15.4.8 Spectrum of Rod Cluster Control Assembly Ejection Accidents

The reactor protection in the event of a rod ejection accident is described in WCAP-15806-P- A7588, ~~Revision 1A~~ (Reference 4). The protection for this accident is provided by the high neutron flux trip (high and low setting) and the high rate of neutron flux increase trip. These protection functions are described in Section 7.2.

Figure 15.4.8-1

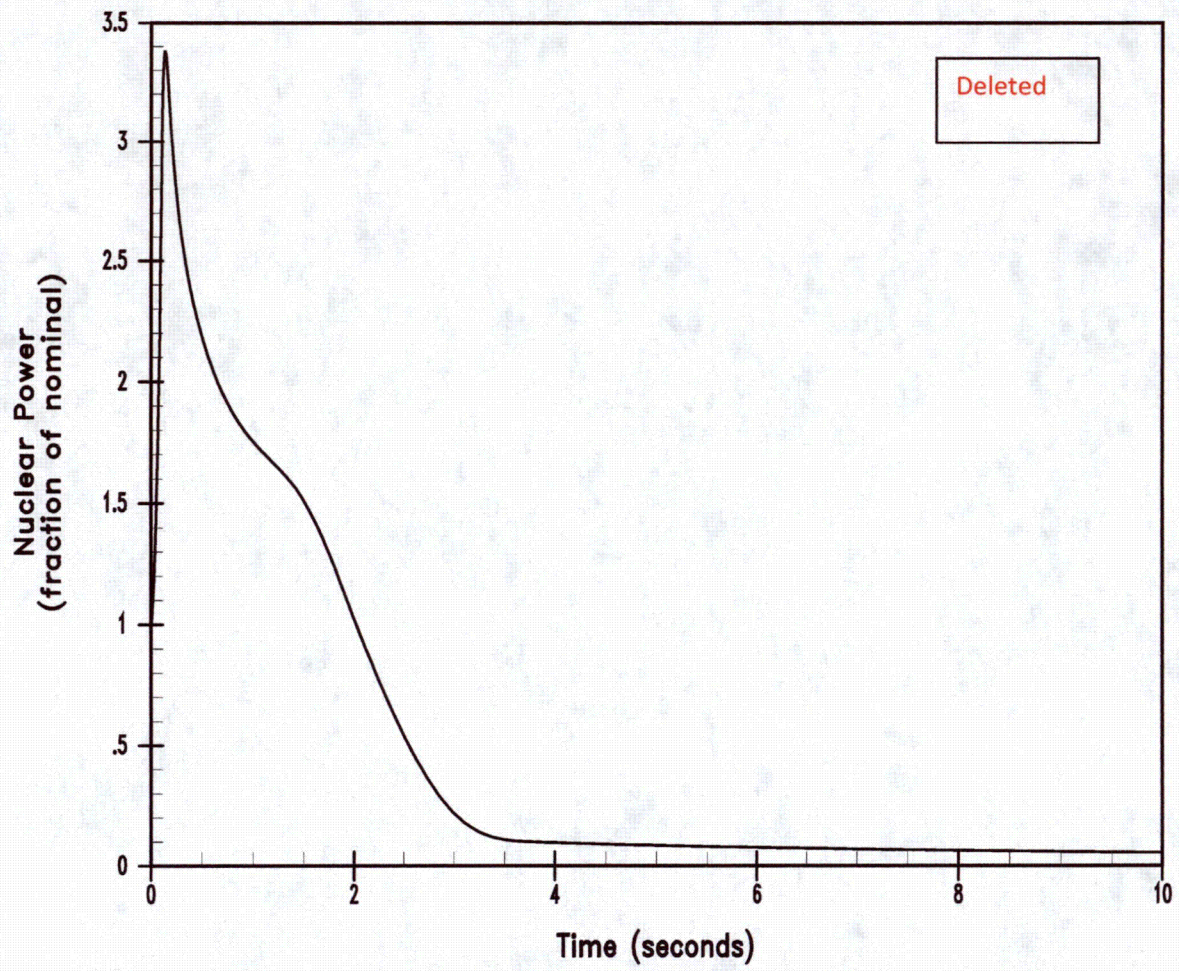
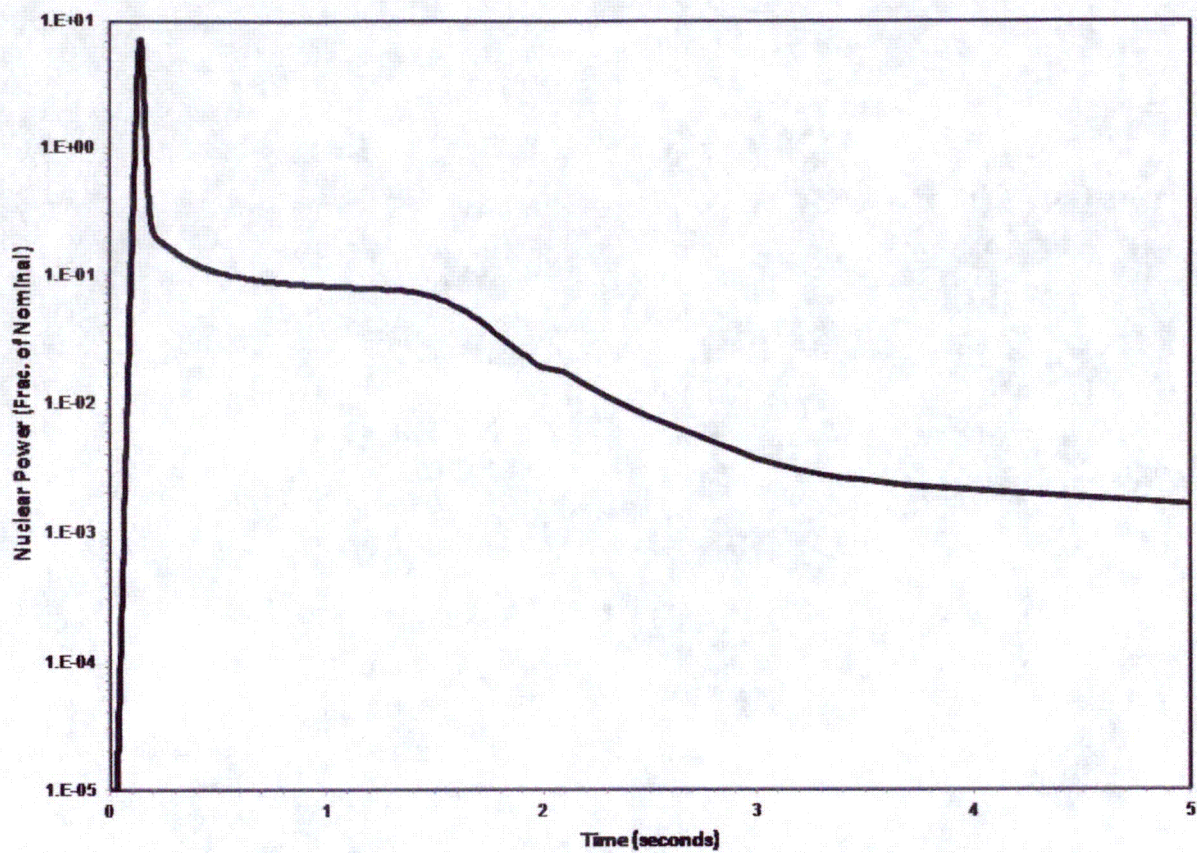
A summary of the preceding cases is given in Table 15.4-3. The nuclear power and fuel and cladding temperature transients for the limiting cases are presented in Figures 15.4.8-1 through 15.4.8-34.

The calculated sequence of events for the limiting cases ~~rod ejection accidents, as shown in Figures 15.4.8-1 through 15.4.8-4,~~ is presented in Table 15.4-1. Reactor trip occurs early in the transients, after which the nuclear power excursion is terminated.

Figure 15.4.8-3

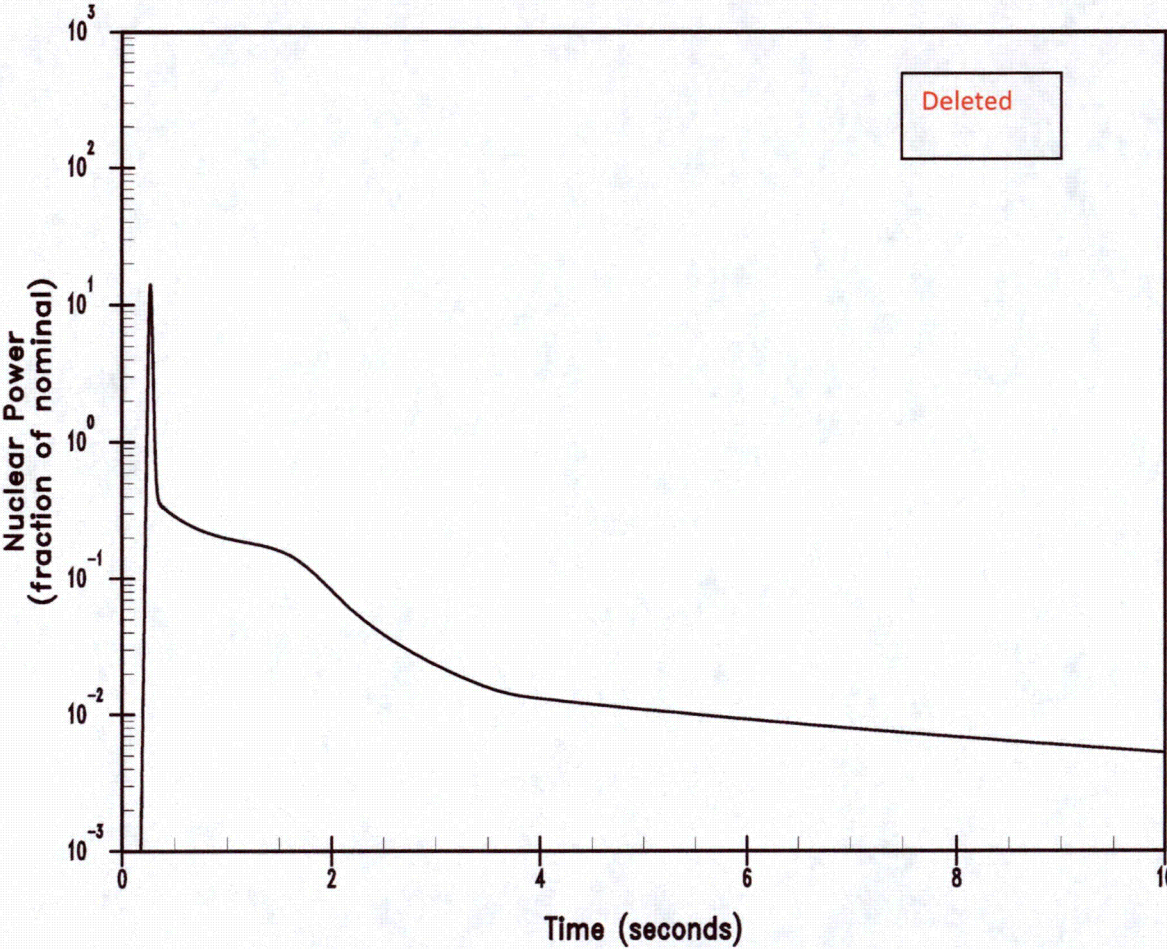
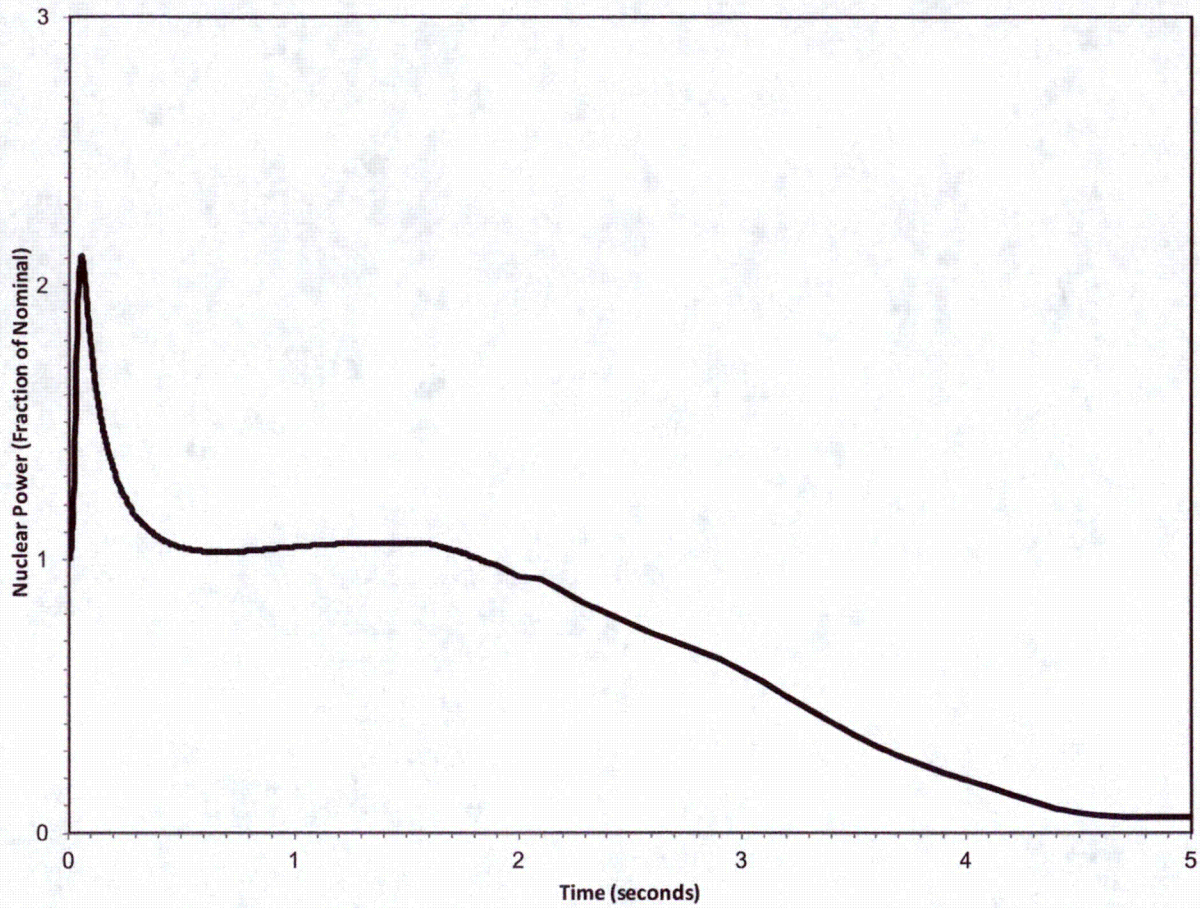
Nuclear Power Transient Versus Time
~~at End of Life, Zero Power~~for the Peak Enthalpy and Fuel Centerline Temperature Rod Ejection
 Accident

Figure 15.4.8-4 not used

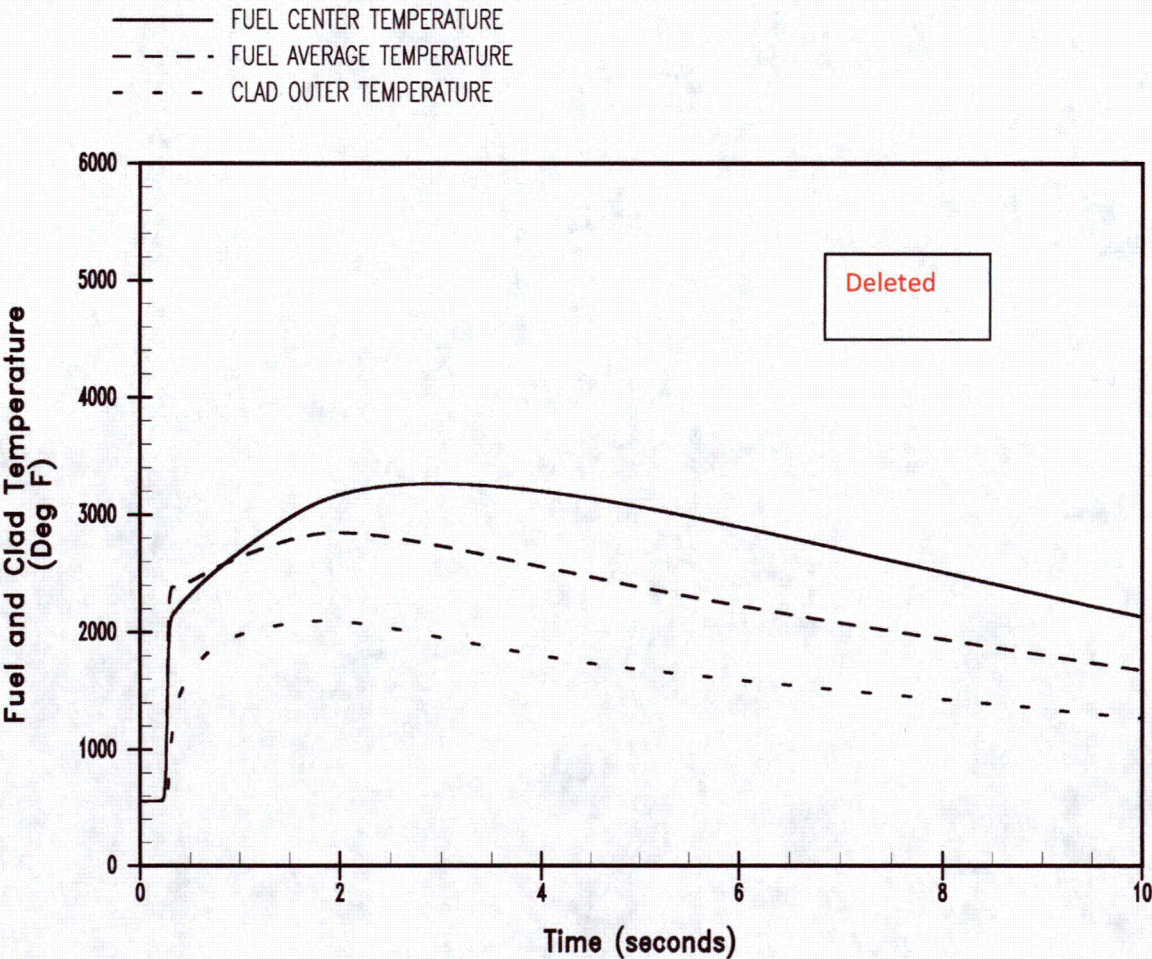
~~Figure 15.4.8-4~~

~~Hot Spot Fuel, Average Fuel, and Outer Cladding Temperature
Versus Time at End of Life, Zero Power~~
